**RE: Westgate Community Center
10001 DeVargas Rd SW
Grading and Drainage Plan
Engineer's Stamp Date: 10/1/19
Hydrology File: M09D030**

Based on the submittal received on 9/3/19, the Grading and Drainage Plan is approved for Building Permit.

Re: Westgate Community Center - Hydrology File: M09D030
COA Hydrology Building Permit Approval Re-Submittal

Sheet: Of:
C-100

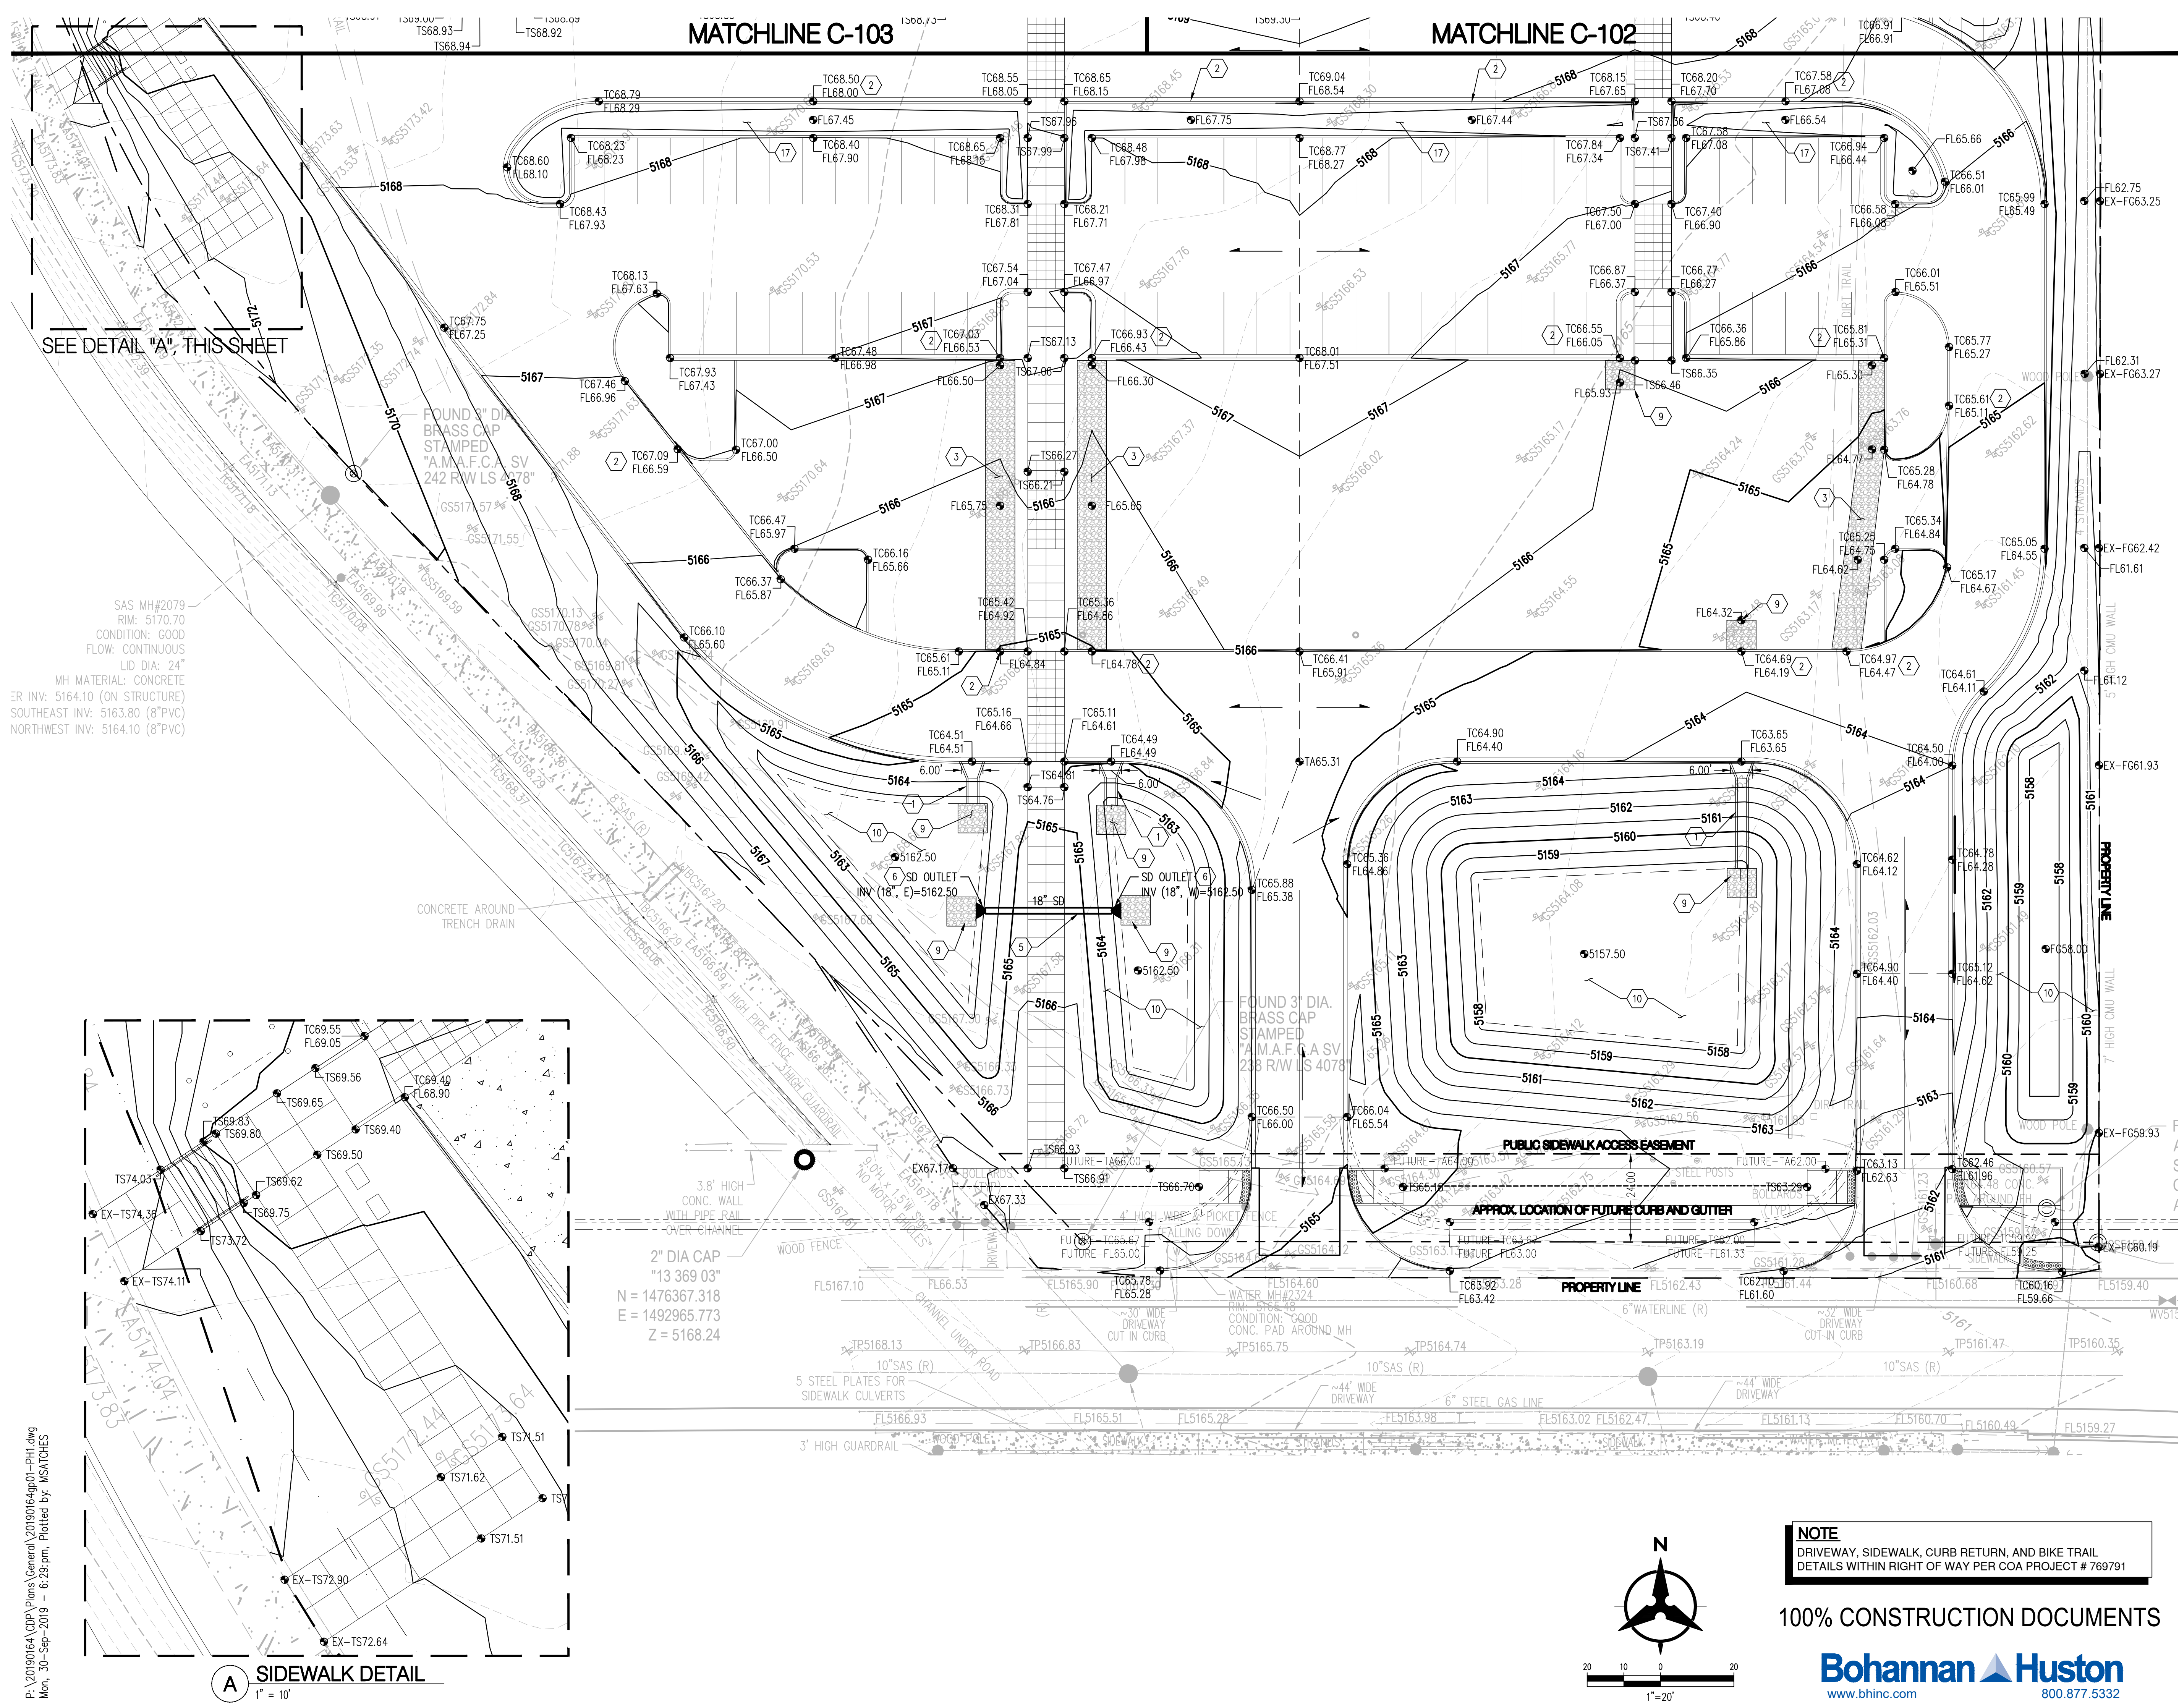
3. Slope stabilization needs to be called out around the western future building pad as well as the berm/swale along the east property line; it may be more reasonable just to reword the general note on C-100 to say "reseed all disturbed areas, including staging areas, per CoA spec section 1012."

Response: General note has been updated to reflect this language.

RESEED ALL DISTURBED AREAS, INCLUDING STAGING AREAS, PER COA SPEC SECTION 1012.

G CHECK DAM
NOT TO SCALE

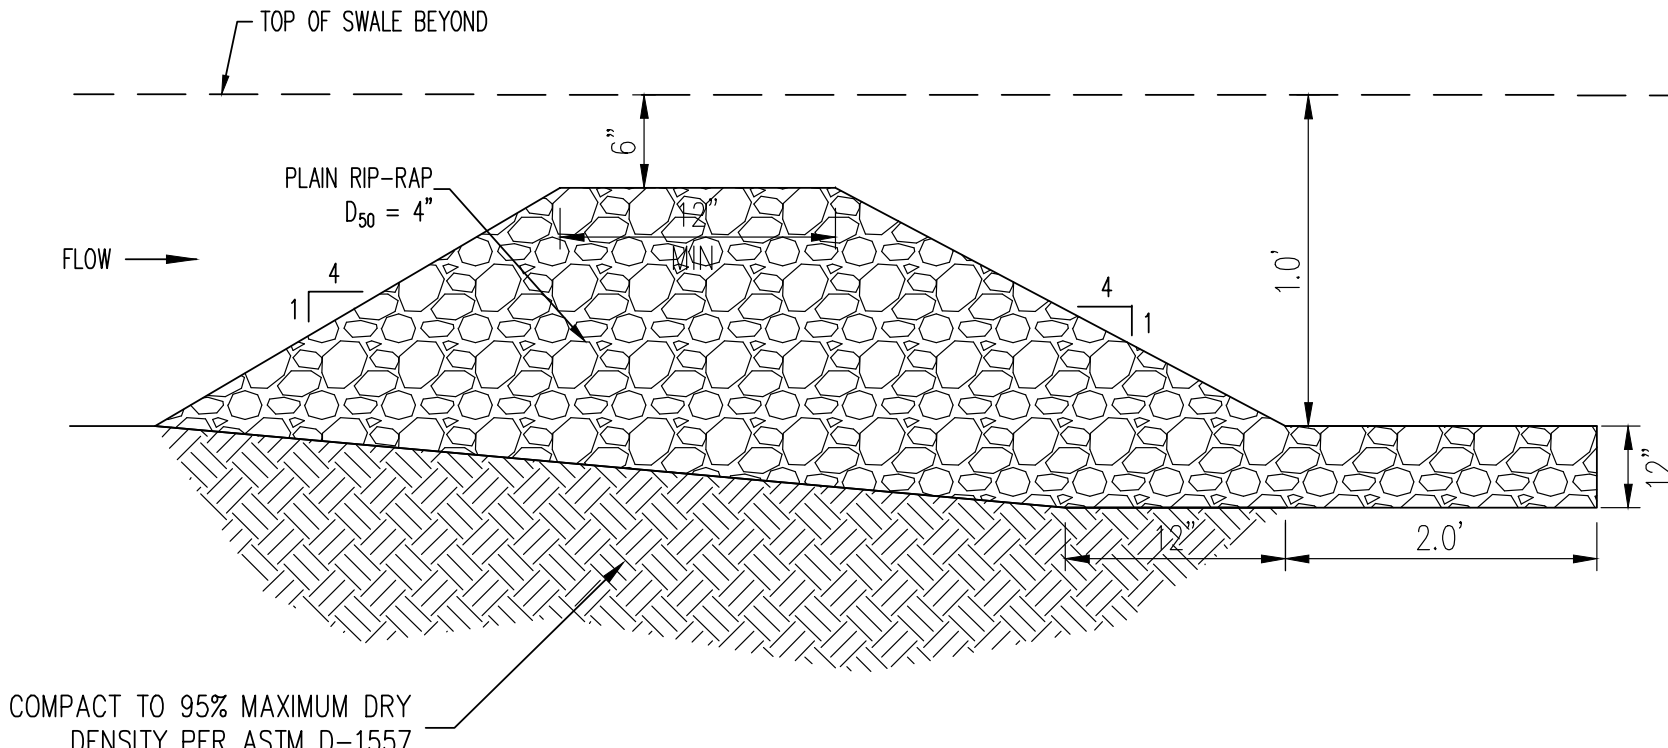
2. Check dams need to be sized and spaced such that the toe of the upstream dam equals the crest of the next downstream dam and provide a sag at midpoint. See NMDOT standards and specifications for temporary erosion and sediment control measures for more details and design standards regarding check dams.

Response: Check dam detail has been updated and placement is based on the crest of the downstream dam and toe of upstream dam per your comment.

- NOTES:
1. SEE PLANS FOR LOCATION OF DAMS.
 2. CHECK DAMS SHALL BE CLEANED OF ACCUMULATED SEDIMENT WHEN THE DEPOSITS REACH APPROXIMATELY ONE-HALF THE HEIGHT OF THE CHECK DAM.
 3. TOE ELEVATION OF UPSTREAM CHECK DAM TO MATCH THE ELEVATION OF THE CREST OF DOWNSTREAM CHECK DAM.
 4. PROVIDE SAG AT MIDPOINT OF CHECK DAM.
 5. REFER TO NMDOT STD DWG 603 FOR TYPICAL CHECK DAM EROSION CONTROL FEATURES.

H EMERGENCY OVERFLOW WEIR
NOT TO SCALE

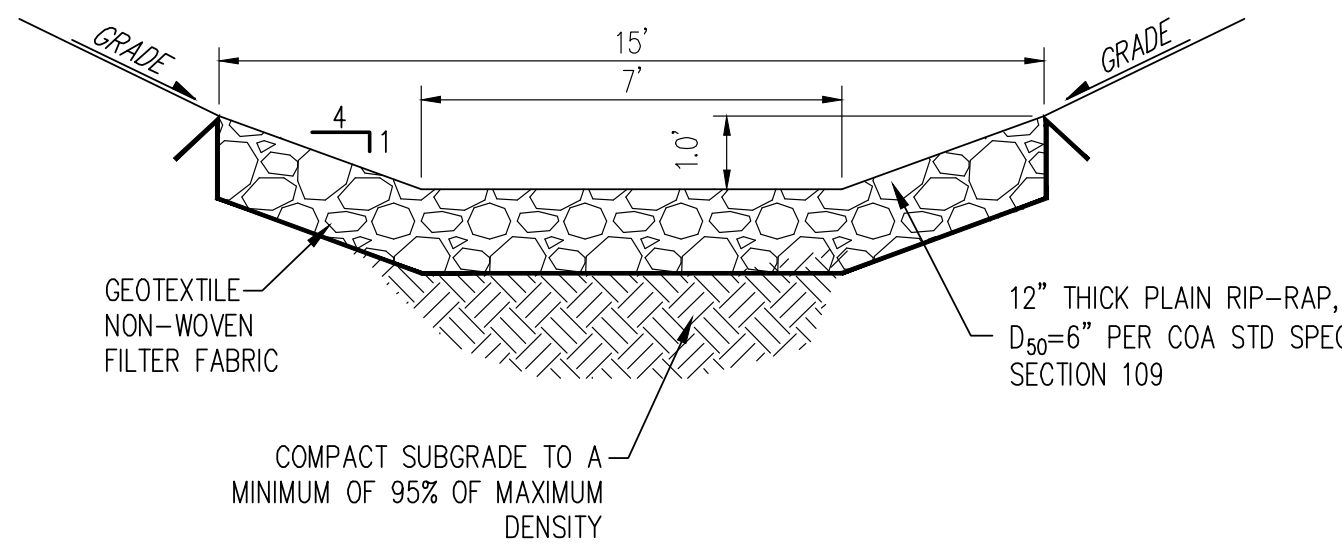
1. Provide an armored emergency overflow from Pond 1; it does not need to be concrete, but it does need to be designed and shown on the stamped grading plan, not the landscaping plan. SW2 is shown in section B-B as a 15' wide swale with unknown depth, but the manning's calculation shows a top width of 45' and a (flow?) depth of 1.63'. The hydraulic calculations must match the section to be constructed. Flow depth needs to be determined in the channel and adequate freeboard provided. Spillway flow depth needs to be determined via the weir equation and adequate freeboard provided along the south and east sides of the pond. Future buildings need to be considered in this design.

Response: Riprap emergency overflow has now been provided. SW2 has been redefined to reflect the appropriate swale cross-section of 15' wide and 1' deep. This spillway is to include 2"-4" rock downstream of the overflow. Weir and Manning's capacities are now provided on the Drainage Management Plan.
